# HOSKEN RESERVE MASTER PLAN REFRESH

*Refresh Group Outcomes Excerpt*

*The following is an excerpt of pages  
48-54 of the Background Report that  
have been updated after conclusion  
of the Refresh Group Process.  
This should be read in conjunction with  
the Refresh Group Engagement  
Process Report.*

**Figure 25. DRAFT Hosken Reserve Master Plan**

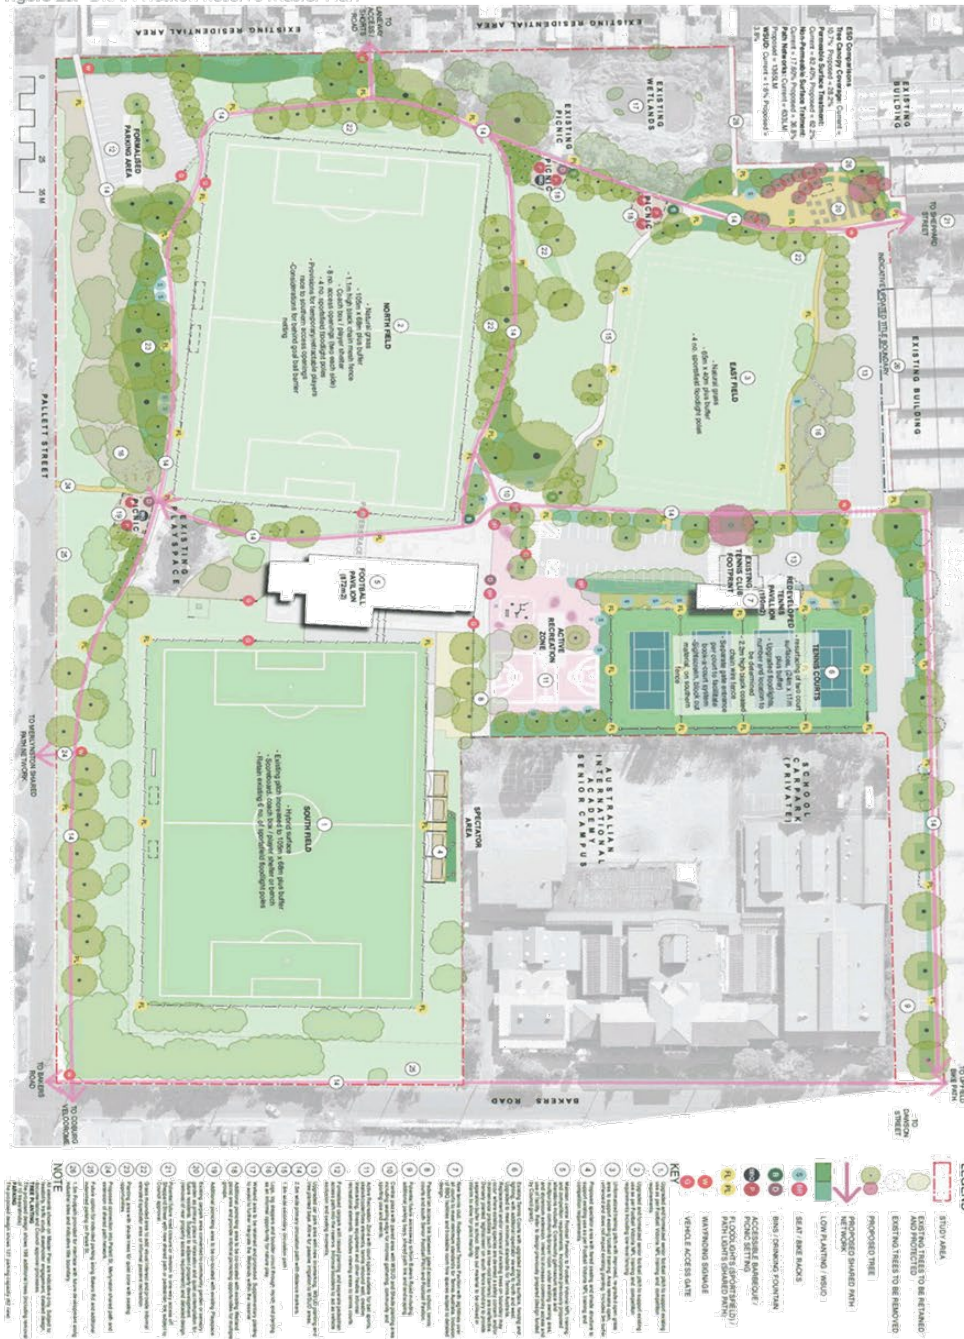
The draft design prepared by the Refresh Group was reviewed by Council officers against Council policy, management practices and operational procedures. This review focused on a number of outstanding matters including:

- North pitch: Confirmation of size
- Community garden: inclusion on site
- Traffic: Bakers Rd entrance, Shepard St treatment, and Pallet St indented parking
- East development sites: relationship of property development on site boundary
- General operational matters: bin placement, emergency/ maintenance vehicle access etc.

A revised design has been prepared that factors in the above review, as shown in the following section. The following specific changes have been applied:

### 1. North pitch: increased to 105m x 68m

It is Council's goal to increase participation in sport, and as there are no spatial site constraints, best practice design would align to Football Victoria's preferred pitch size of 105m x 68m on the North Oval.

### 2. Carpark: East boundary alterations

Council's Strategic Planning and Urban Design team indicated a preference for siting the car parking adjacent to the East field rather than the Shepard St boundary.

### 3. Central plaza: relocation

It was recommended that the central plaza be shifted further East so that the new trees proposed don't inhibit views from the football pavilion to the field of play. In doing so, sightlines from the carpark to the playground and surrounds is also improved.

### 4. Vehicle access: clear delineation

To ensure vehicular access is appropriately catered for during detailed design phases, the proposed vehicle access points have been more clearly identified on the map. This includes identification of access to the South pitch on both the East and West ends of the football pavilion for maintenance vehicles.

### 5. Shared User Path: Ulm St connection

Feedback from the community to formalise the existing desire path from the playground to Ulm St was supported by officers. The use of stairs or other treatment down the steep ridge is acceptable in recognition of the DDA compliant path provided further South.
